ADMINISTRATIVE AMENDMENT (FPA) ADD2016-00206A

**ADMINISTRATIVE AMENDMENT
LEE COUNTY, FLORIDA**

**FINAL PLAN APPROVAL
FOR
MIROMAR LAKES
SARDINIA
LEE COUNTY, FLORIDA
DATE: DECEMBER 2016**

Date: December 12, 2016
To: Anthony Palermo, Senior Planner
From: Beth Workman, Environmental Planner
239.533.8793
EWorkman@leegov.com
Subject: Sardinia at Miromar Lakes
ADD2016-00206

MASTER CONCEPT PLAN

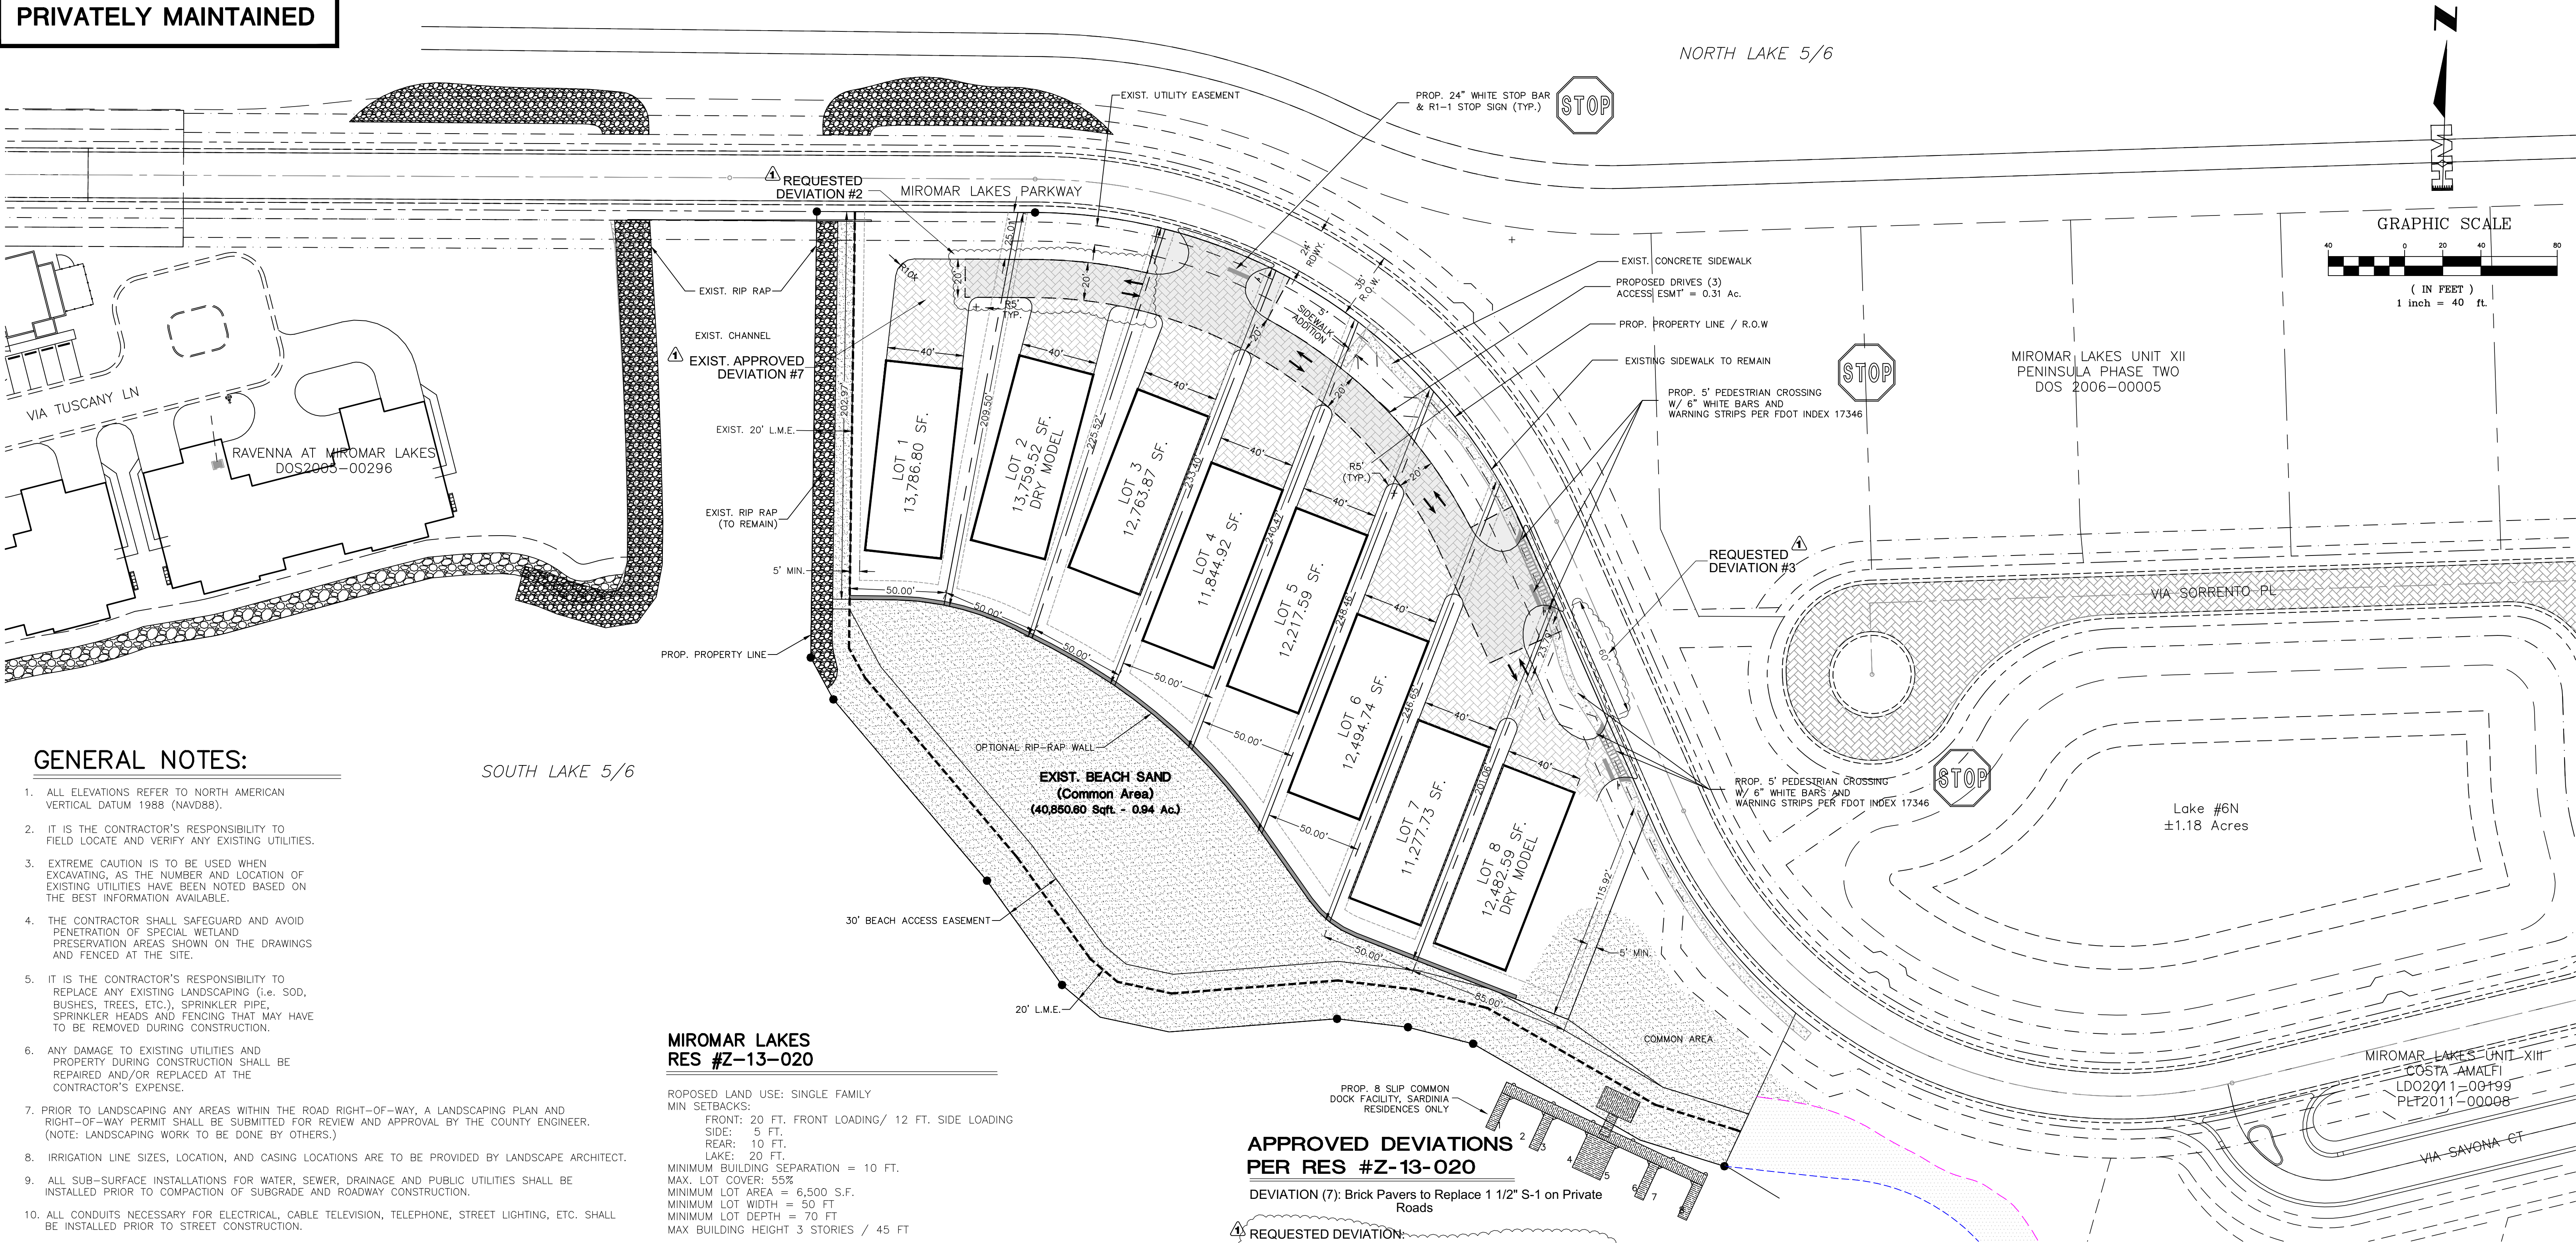
WHEREAS, the applicant requests a new deviation from LDC Sec. 10-296(p)(1) to allow the proposed internal access way to terminate in a dead end without a cul-de-sac (Attachment "E"); and

WHEREAS, the applicant requests a new deviation from LDC Sec. 10-285(a) to allow for a reduction in the minimum driveway connection separation distance for a local street from 125 feet to 60 feet; (Attachment "E"); and

- REQUESTED DEVIATION:
- Deviation from LDC 34-1954(b)(2) to allow dry models.
 - Deviation from LDC 10-296(p)(1) to allow internal access drive to end without a cul-de-sac.
 - Deviation from LDC 10-285(a) to allow a reduction in the required 125 ft separation for driveway connections.

- a. Approval is limited to single-family development consistent with the Final Plan Approval: Site Plan per Attachment "A".
 - b. Prior to Development Order approval for the internal access way terminating in a dead end without a cul de sac per Deviation #2, approval from the fire district must be obtained.

- 8. A deviation from LDC Sec. 10-285(a) to allow for a reduction in the minimum driveway connection separation distance for a local street from 125 feet to 60 feet is approved with the following condition:

- a. Approval is limited to single-family development consistent with the Final Plan Approval: Site Plan per Attachment "A".

SITE PLAN

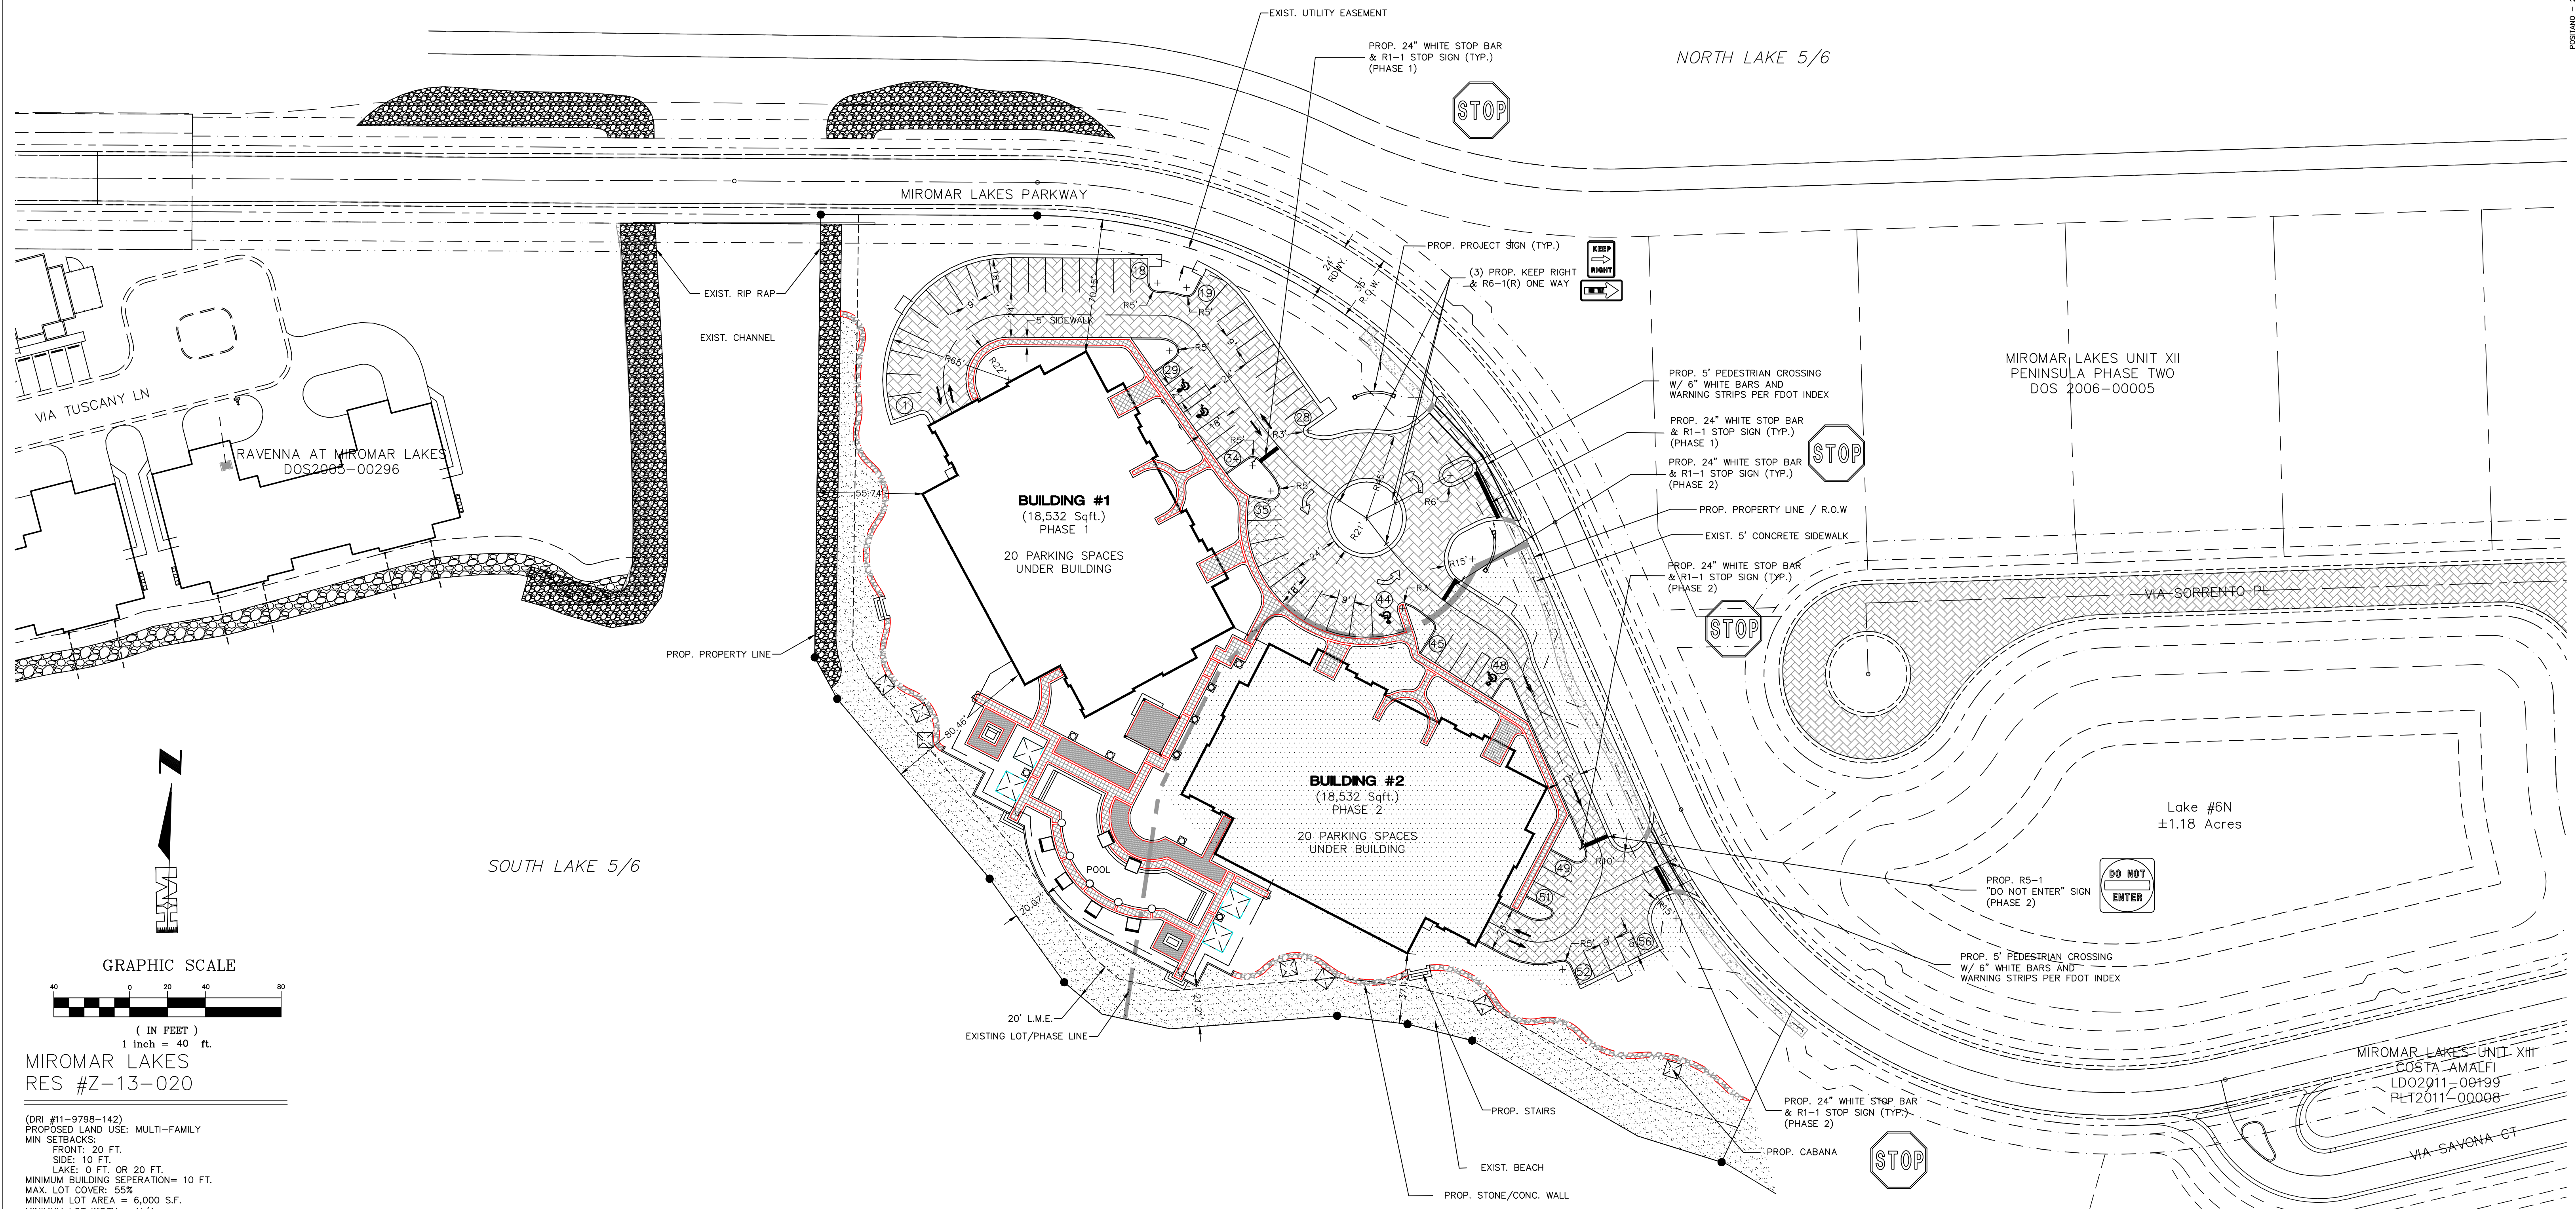
WHEREAS, the proposal includes utilization of Deviation 7 approved per Zoning Resolution Z-13-020 to permit the use of brick pavers on private roads within Miromar Lakes (Attachment "B"); and

3. **Deviation #7 per Zoning Resolution Z-13-020 is approved with the following conditions:**
 - A. **The proposed stone/concrete wall must be removed from the lake maintenance easement prior to Development Order approval.**

- B. **A structural equivalency analysis for the pavers vs. asphalt must be submitted with the Development Order application.**
 - C. **The parking layout underneath the building must be provided with the Development Order application.**
